## Tx Rx Filter v1.0 PCB Errata

17th Aug, 2017

18th Oct, 2017

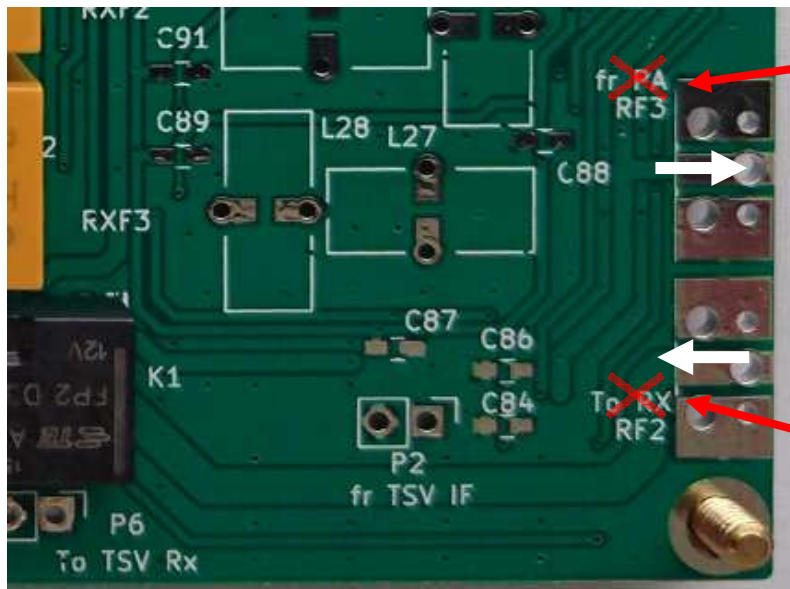
### 1) Wrong Silk

The silks near RF2 and RF3 are swapped

RF3  
from HPF  
to RX (HLv2)

RF2  
from PA (HLv2)  
to T/R relay

### 2) Leakage current

Leakage occurred from DB10-1(+12V source) to +3.3V through Relay driver (TPL 7407) while HL2 turned off. Add high side switch.
